# Access Compliance Report

## Public Rights-of-Way

### (Curb Ramps)

Intersection ID: 7969	Main Street: BROOKSHIRE_BV	Cross Street: N_HOSKINS_RD	Location: NW
ADA ID: 75BDDF2916EB	Ramp Type: Para	Initial Pass/Fail: Fail	Overall Compliance: No
			Severity Score: 26.25

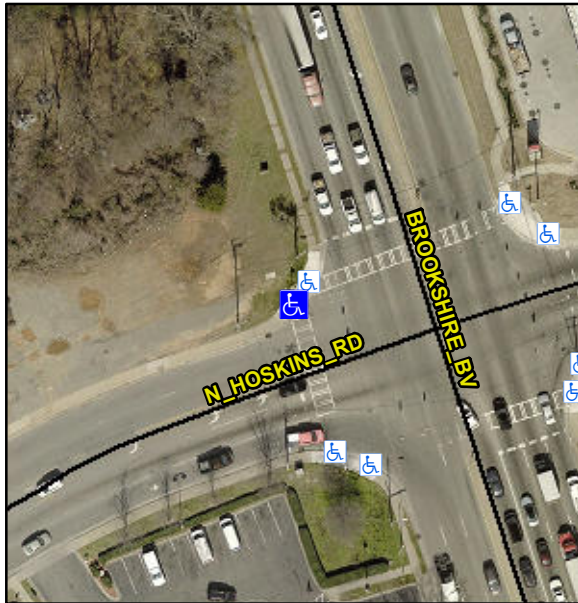
**LT RP < 5%**

**R304.5.3, R304.3.2**

Compliance	Description	Data	Compliance	Description	Data
N/A	Ramp Length LT (in)	64.5	N/A	Ramp Length RT (in)	71.0
Yes	Ramp Width LT (in)	72.0	Yes	Ramp Width RT (in)	72.0
Yes	Ramp Slope LT (%)	2.6	No	Ramp Slope RT (%)	13.3
No	Ramp XSlope LT (%)	2.2	Yes	Ramp XSlope RT (%)	2.0
N/A	Landing Length (in)	N/A	N/A	DWS Provided?	N/A
N/A	Landing Width (in)	N/A	N/A	DWS Contrast?	N/A
N/A	Landing Slope (%)	N/A	N/A	DWS Length (in)	N/A
N/A	Landing X Slope (%)	N/A	N/A	DWS Full Width?	N/A
N/A	Landing Curb? (Y/N)	N/A	N/A	DWS Offset (in)	N/A
N/A	Shared Landing?	N/A			
N/A	Gutter Ponding?	N/A	N/A	Gutter Slope (%)	N/A
N/A	Gutter Lip Ht (in)	N/A	N/A	Gutter X Slope (%)	N/A
N/A	Painted X Walk1?	Yes	N/A	Painted X Walk2?	N/A
	X Walk 1 Direction	To S		X Walk 2 Direction	N/A
N/A	X Walk 1 Width (in)	97.5	N/A	X Walk 2 Width (in)	N/A
	X Walk 1 Slope (%)	2.4		X Walk 2 Slope (%)	N/A
	X Walk 1 X Slope (%)	6.6		X Walk 2 X Slope (%)	N/A
N/A	Ramp inside XWalk1?	Yes	N/A	Ramp inside XWalk2?	N/A

**Remove & Replace Entire Ramp.**
